# Historic Preservation Board Regular Meeting

**July 14, 2021 @ 9:00 am**

- c. [COR #20-07 Request of Zach Mitchell: Approval to renovate and expand the existing home at 723 Maryland Avenue located in the College Quarter Historic District. Zoned: R-2.](#) 30 minutes

COR 21-05 Request of Ron Scarpa to restore the 1941 existing cottage at 767 McIntyre Avenue and build a new two-story, residence to the rear.

1 SITE PLAN  
1/8" = 1'-0"

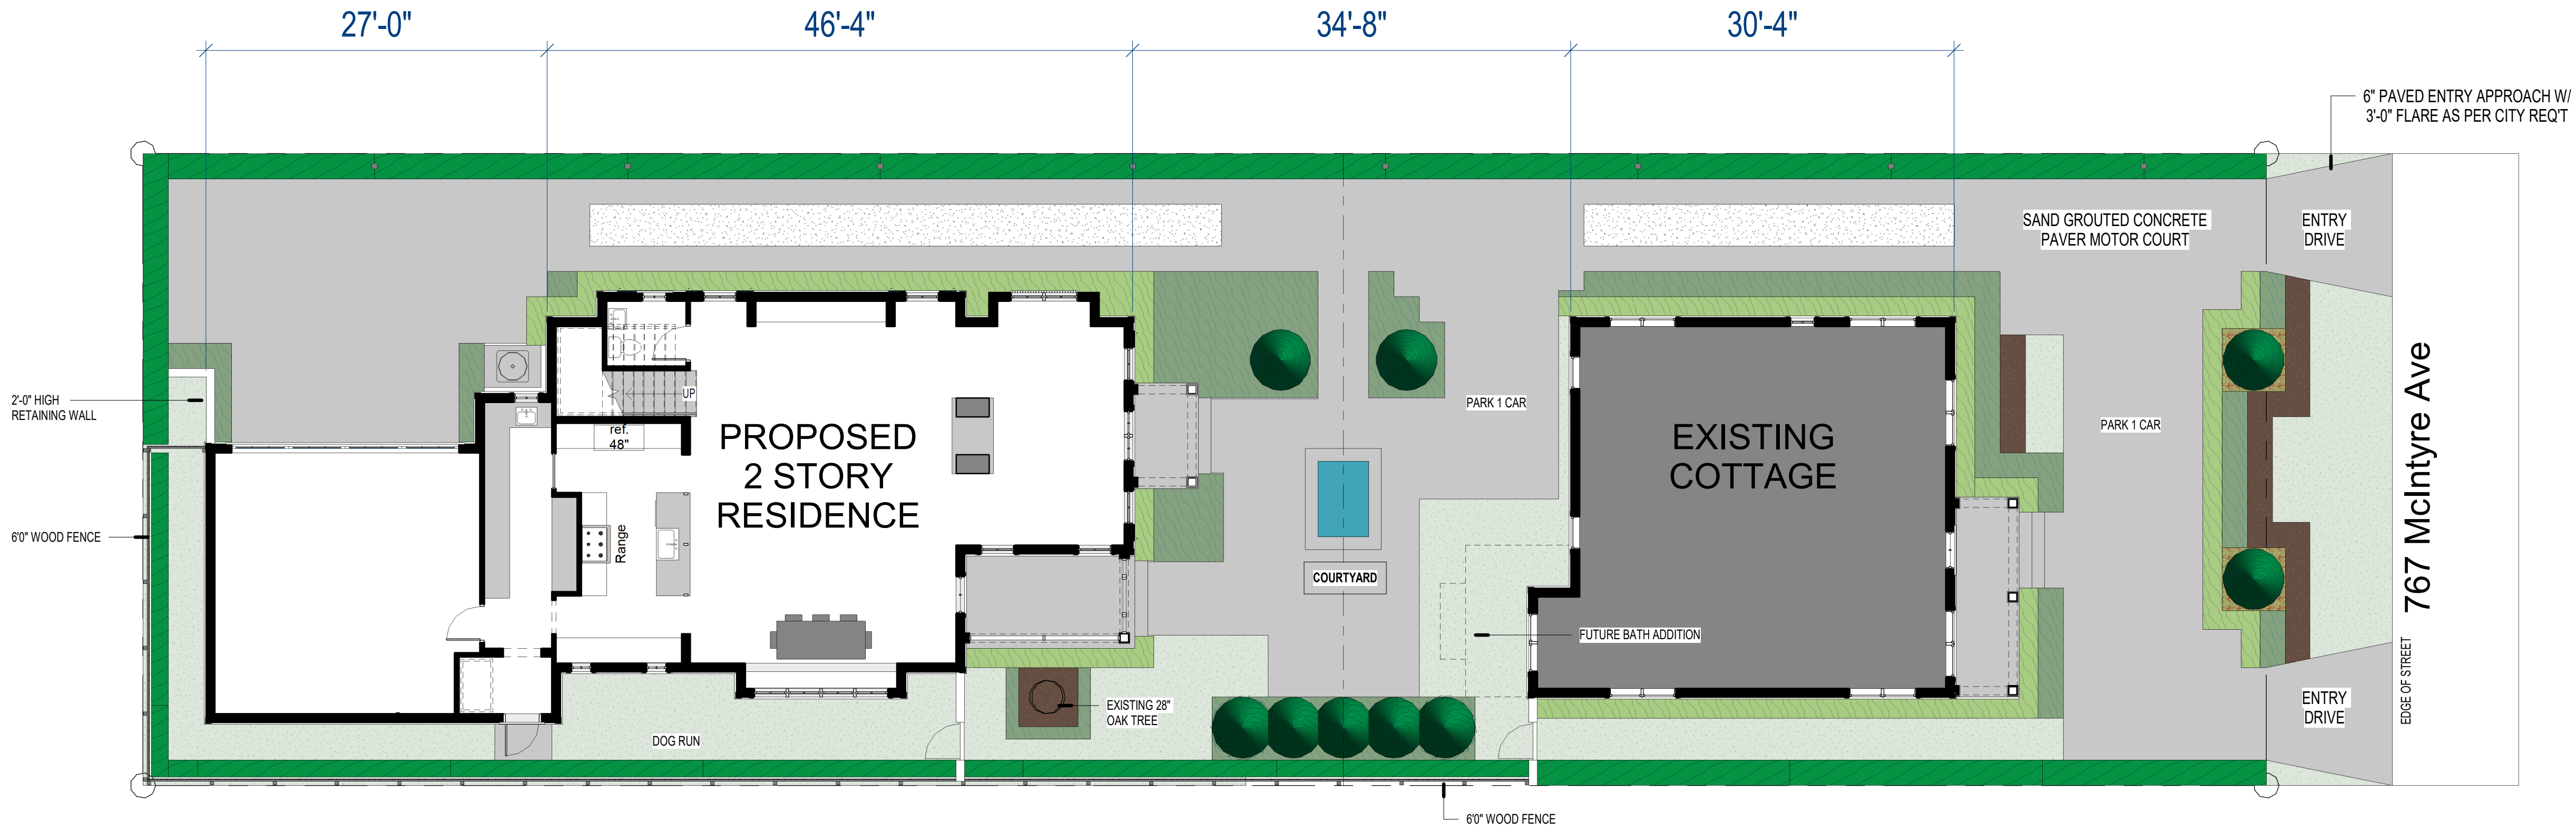
There are three variances requested, that relate to the setbacks for the new two-story home. The required side setback (South Side) is 7 feet to the one-story component of the structure and 10 feet to the two-story component of the structure. The plans request a 9-foot setback for both floors.

The second setback variance is for the garage portion of the new home which has a rear setback (West side) at 5 feet in lieu of the 25-foot setback required for this two-story component of the structure. When the gable end faces the neighbor and the structure is taller than 17 feet, then it is deemed to be a two-story structure.

The third setback variance is the same scenario for the side setback for the garage which is at 5 feet in lieu of the required 10-foot setback. Staff is comfortable with these setback variances provided that the affected neighbor(s) are not in opposition.

A fourth variance is to provide one of the required parking spaces for the front existing

Front Elevation  
1/4" = 1'-0"

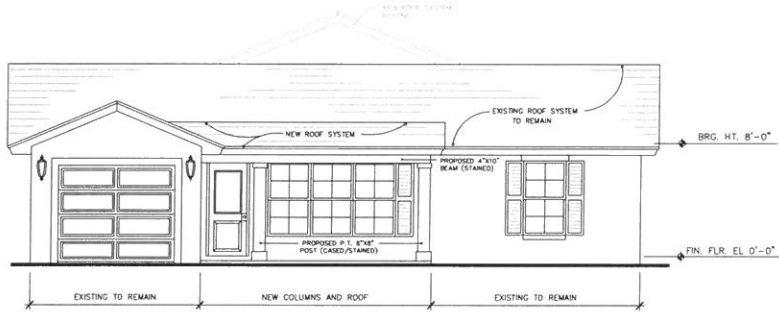
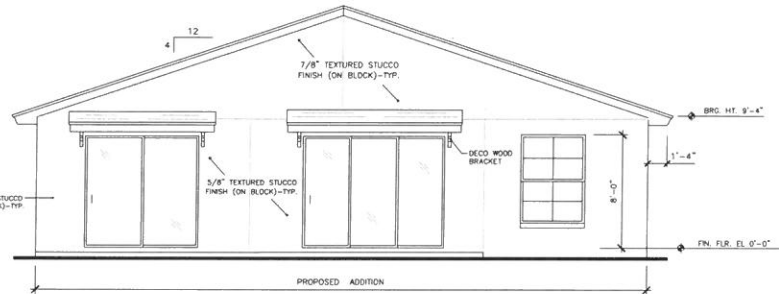
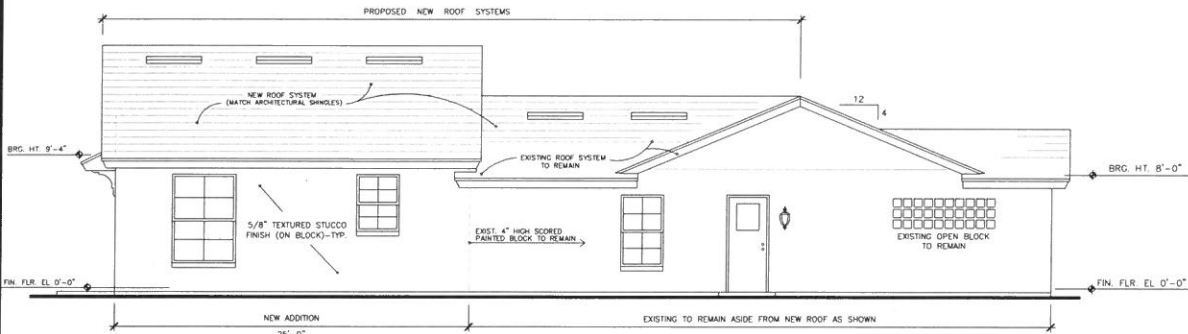
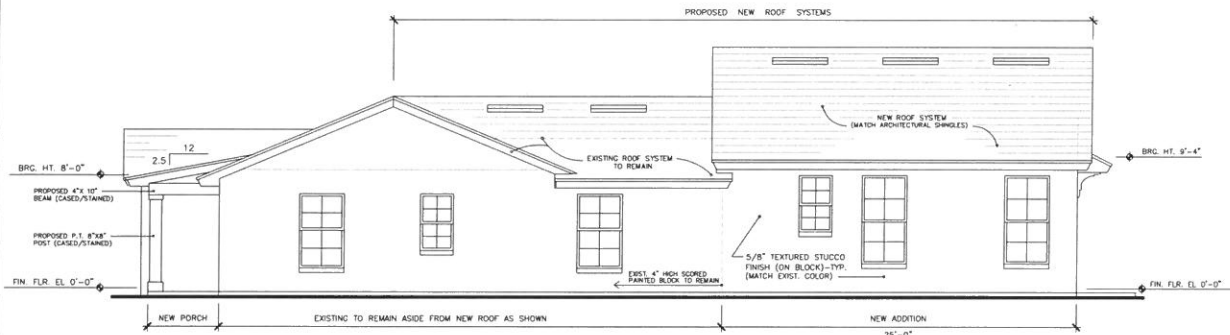
The applicant is asking to change the window fenestration from six over six to four over four and to eliminate the shutters. Certainly, there are other Minimal Traditional homes with four over four and no shutters. However, the City does not require that renovations include authentic materials from the 1948 era. All we ask (especially in return for variances) is to make the exterior look the same as it looks now. Staff will recommend conformance to the current appearance.

1. Maintain the existing window fenestration of six over six and add shutters where appropriate.
2. Modify the roof height differential as the Historic Preservation Board may suggest.
